Model: Ti-P1		Date: 21-May-13	No.: RM109001
Subject: IEEE802.11 Interface Unit Type O Notification		Prepared by: Y. Suzuki	
From: 3rd Tech Service Sect.,MFP/P Tech Service Dept.			
Classification:	<input checked="" type="checkbox"/> Troubleshooting <input type="checkbox"/> Mechanical <input type="checkbox"/> Paper path <input type="checkbox"/> Product Safety	<input type="checkbox"/> Part information <input type="checkbox"/> Electrical <input type="checkbox"/> Transmit/receive <input type="checkbox"/> Other ()	<input type="checkbox"/> Action required <input type="checkbox"/> Service manual revision <input type="checkbox"/> Retrofit information <input checked="" type="checkbox"/> Tier 2

Important Notice about the IEEE802.11 Interface Unit Type O

Model: Ti-P1	Date: 05-Jun-13	No.: RM109002h
--------------	-----------------	----------------

Subject: Firmware Release Note: Engine		Prepared by: H. Kobayashi	
From: 2nd Tech Service Sect., MFP/Printer Tech Service Dept.			
Classification:	<input type="checkbox"/> Troubleshooting <input type="checkbox"/> Mechanical <input type="checkbox"/> Paper path <input type="checkbox"/> Product Safety	<input type="checkbox"/> Part information <input

Old Lower Transport Guide

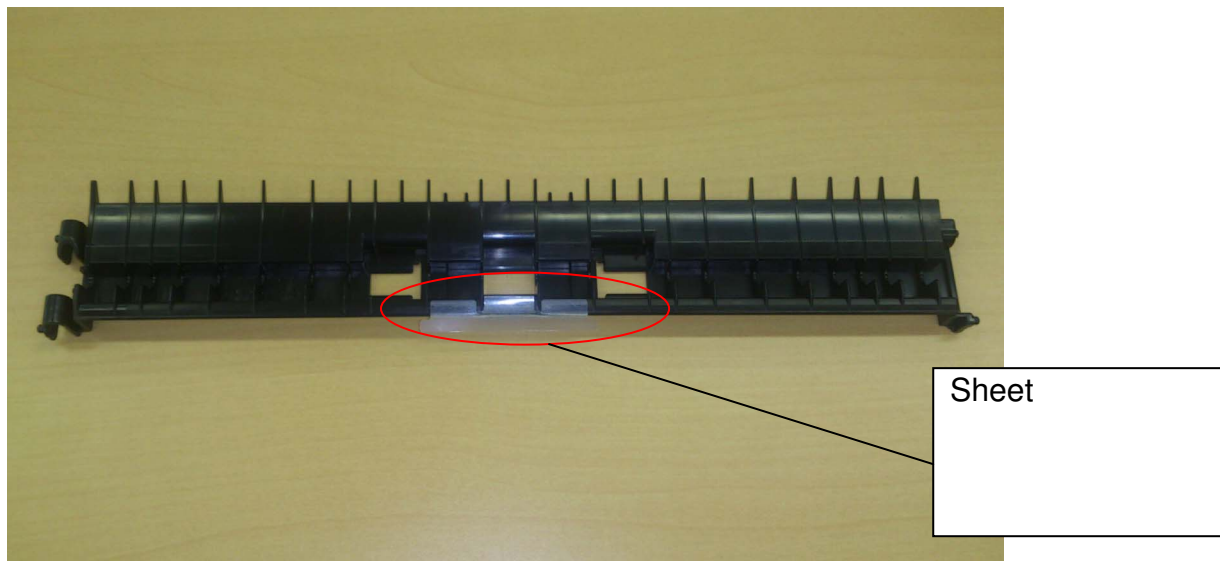
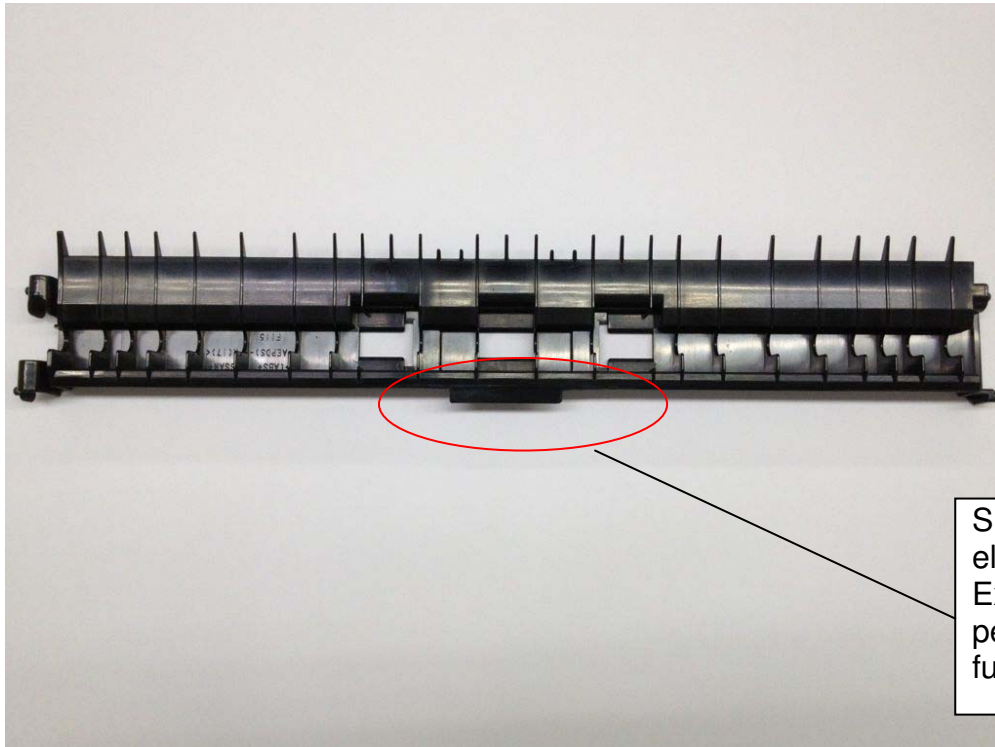
The sheet attached to the lower transport guide may partially peel off.

The sheet was removed and the shape of the lower transport guide was changed. The portion that was extended (circled below) performs the same function as the sheet.

Replace the lower guide plate and sheet with the new lower guide plate (new service part).

Shape change of the Left Stand Fix (P/N: M1091083):

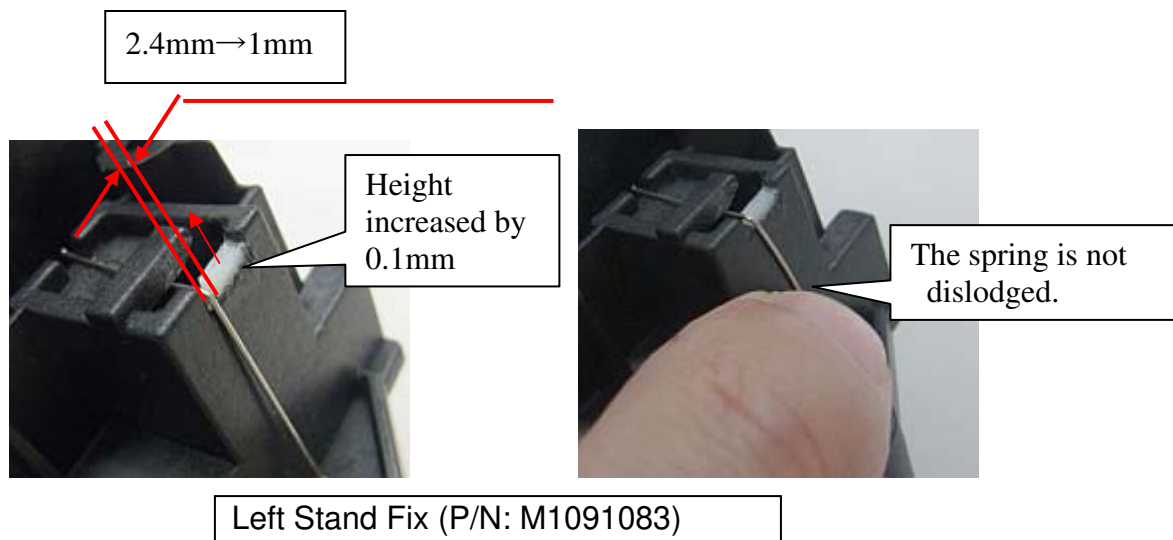
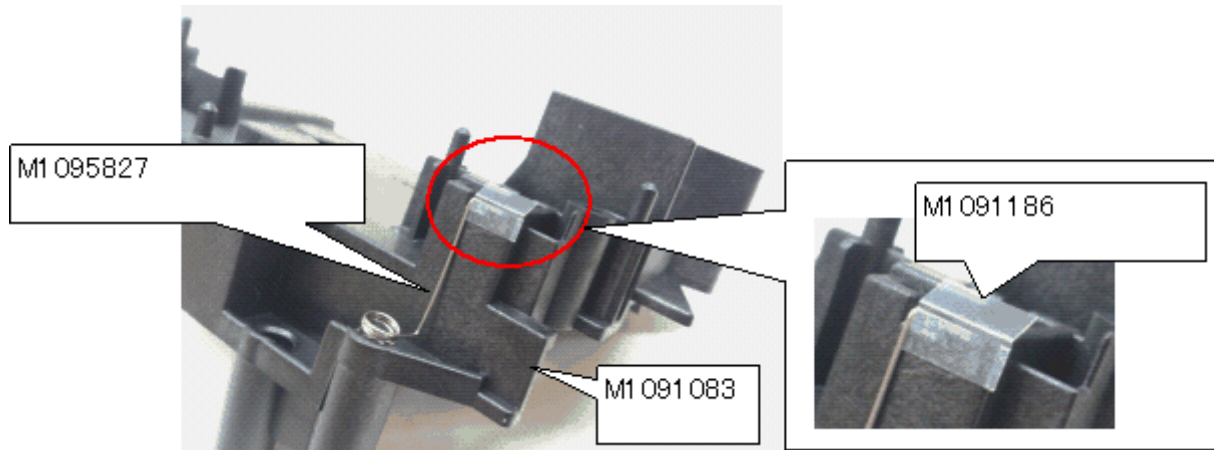
Change: The Connecting Base Spacer, which holds the Second Transfer Compression Spring (P/N: M1095827) in place, was deleted from the production line.

Note: When the spacer was deleted from the production line, the shape of the Left Stand Fix (P/N: M1091083) was changed. The P/N for this part was not changed. **See the photographs below.**

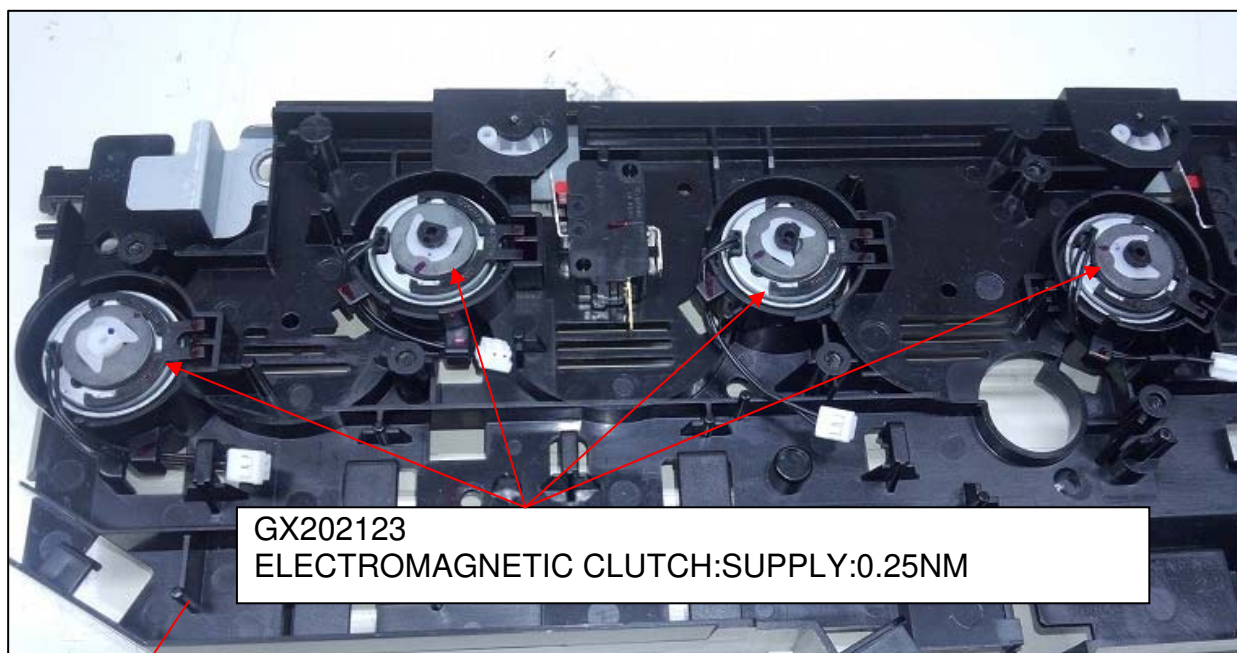
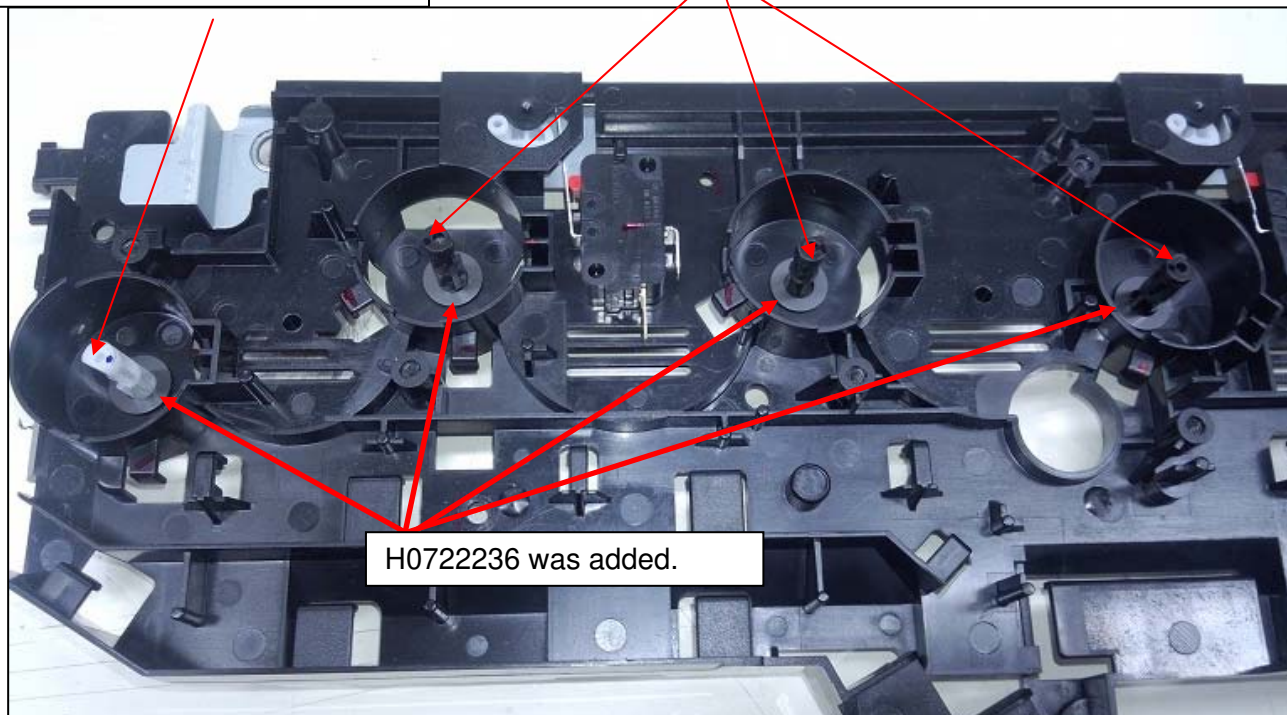
Change: The M12x6.2 spacer located between the gear and clutch was deleted from the production line.

Note: This spacer was originally added from first production in order to reduce noise generated by the gear and clutch. When the spacer was deleted from the production line, the shape of the Toner Supply Drive Bracket (P/N: M1091135) was changed. The P/N for this part was not changed. **See the photographs below.**

M1091135:
BRACKET:DRIVE:TONER
SUPPLY:ASS'Y

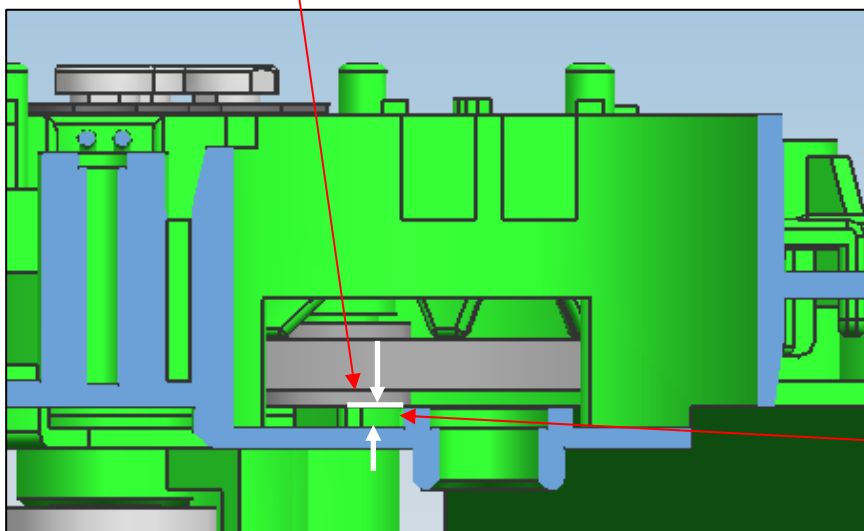
Height of rib on toner
supply drive bracket
increased:
 $0.85 \pm 0.1 \rightarrow 1.15 \pm 0.1$

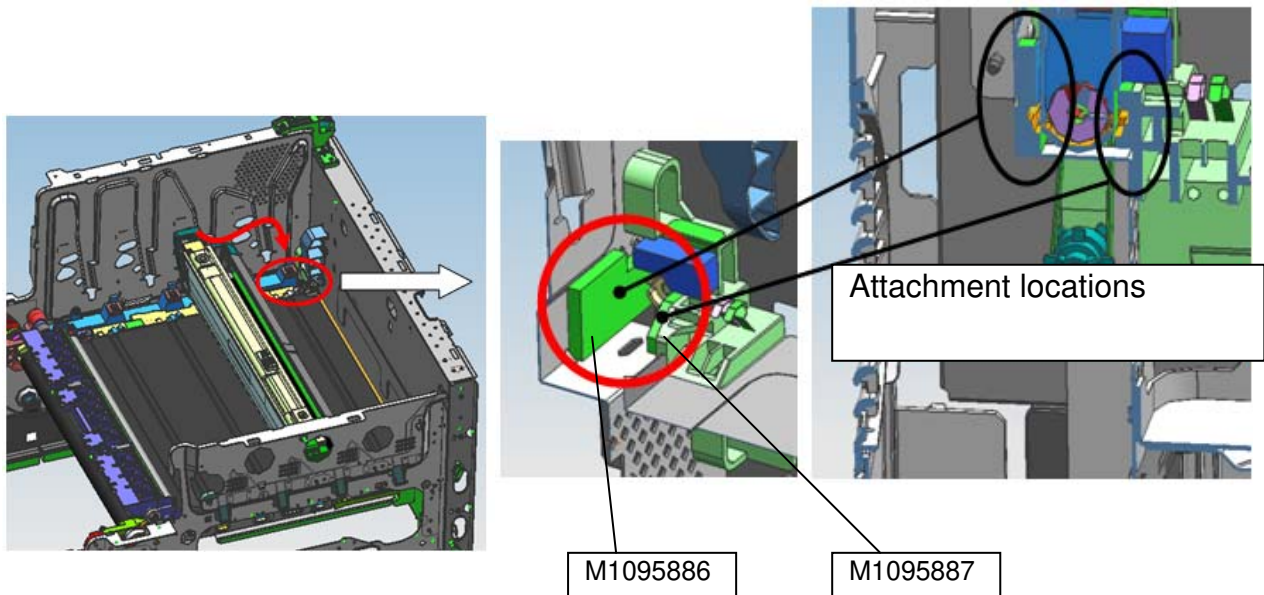
Change: Two seals were added to the waste toner duct section.

Reason: To further improve the sealing of the waste toner duct section.

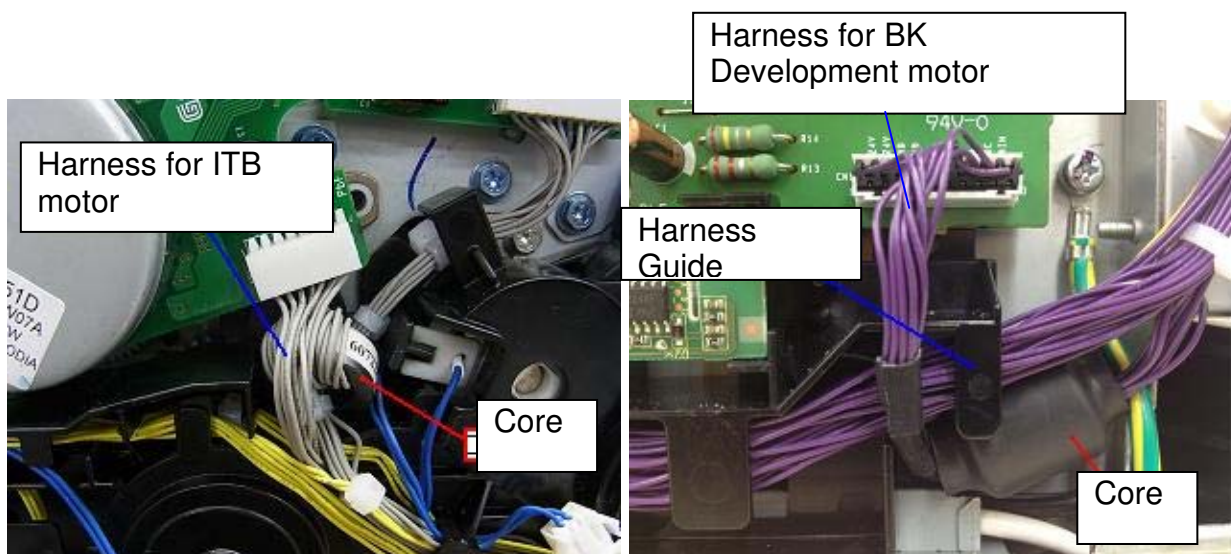
Change: Two ferrite cores were added to the lower drive EGB harness.

Reason: To further minimize electromagnetic interference.

Upper Cover: Modification 1

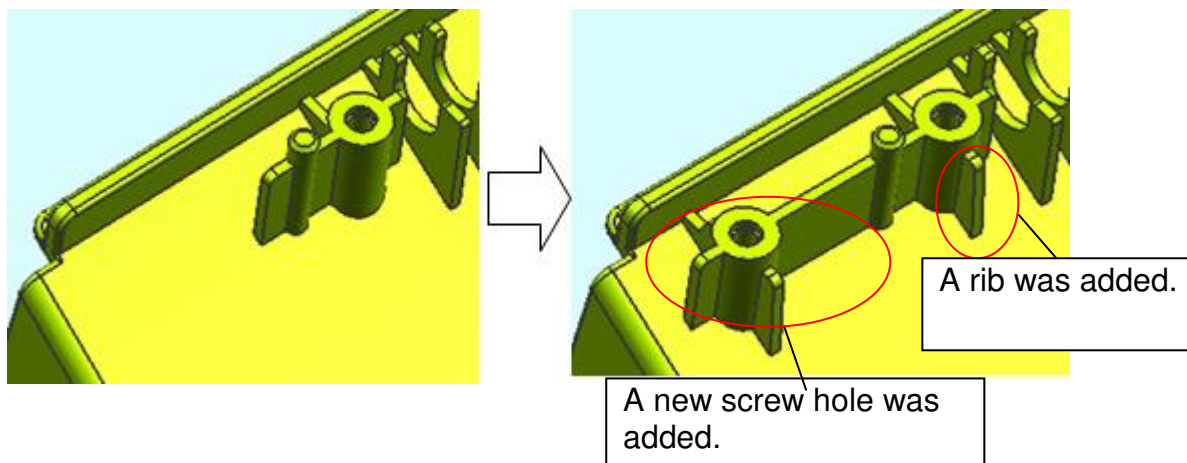
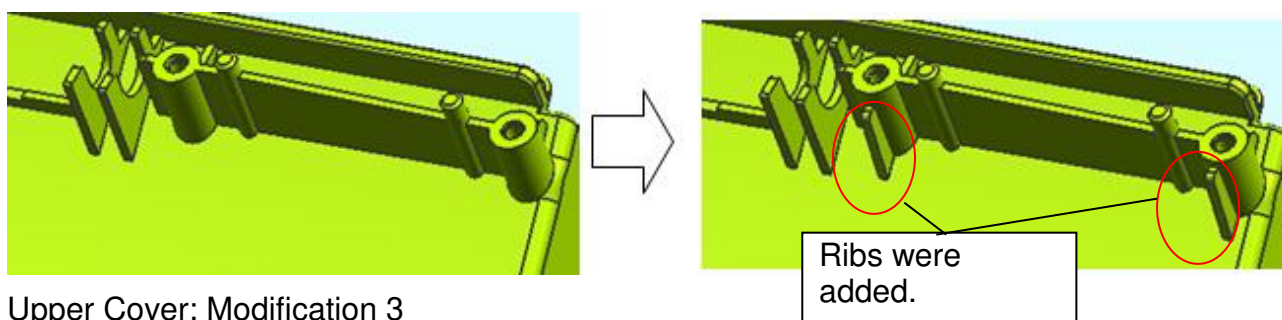
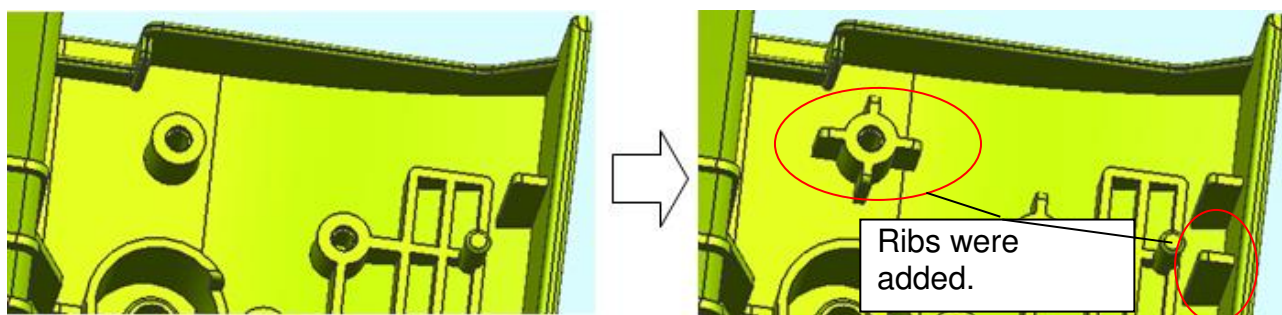
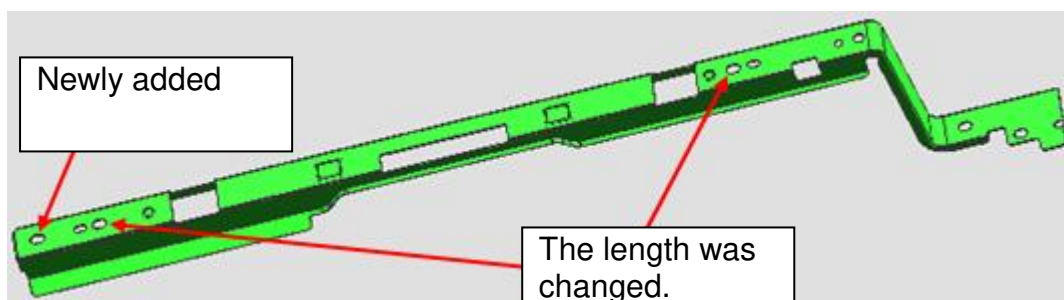
Change:

Note: If you need to replace the old Upper Cover or old Upper Cover Supporting Plate in the field, make sure to install the new Upper Cover and new Upper Cover Supporting Plate **together as a set**.

Old PCDU

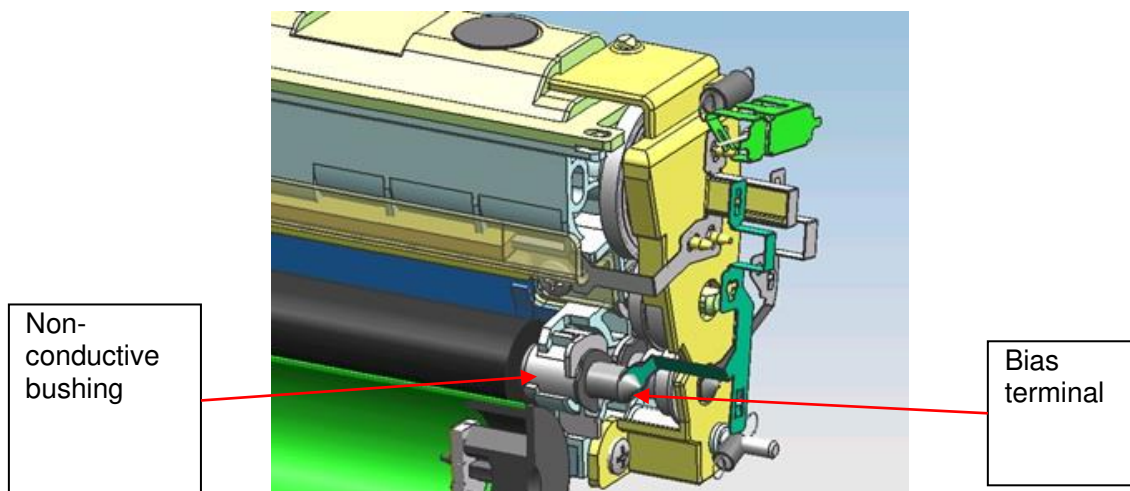
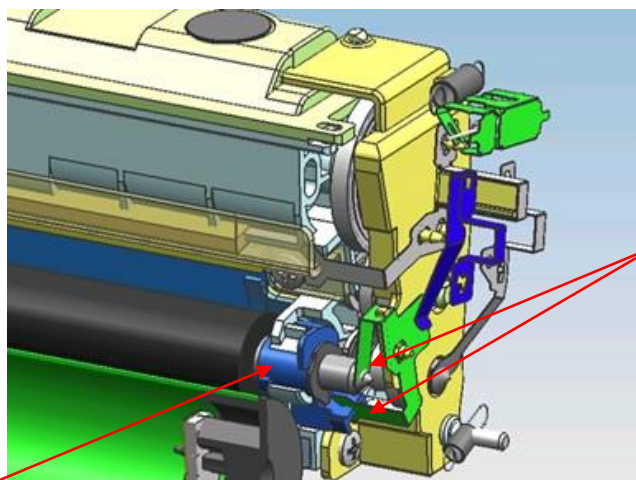
- 1) A second bias terminal was added (for application of the development bias).
- 2) The bushing for the development roller was changed from a non-conductive to conductive one.

Reason: To apply the development bias more consistently across the development roller surface.

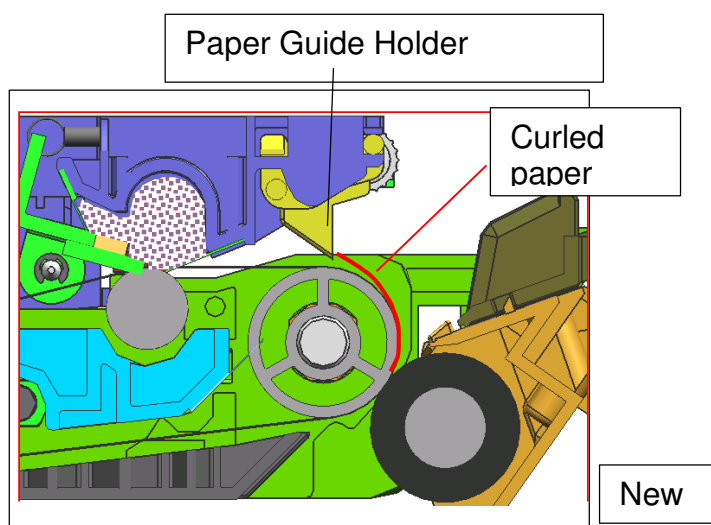
The shape the Paper Guide Holder was changed so as to block curled paper from entering the ITB unit.

Old Paper Guide Holder

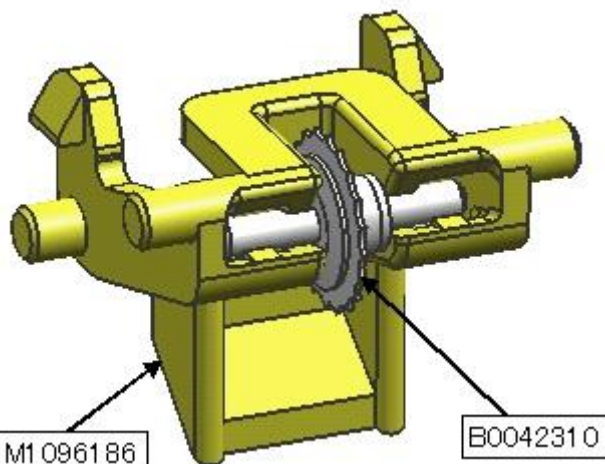
- The shape of the paper guide holder was changed.
- The modified paper guide holder was newly registered as a Service part.
- The spur was registered as a Service part to facilitate servicing in the field.
- The paper guide holder and spur were deleted from the ITB cleaning sub-unit

Replace the paper guide holder or ITB unit with the modified one.
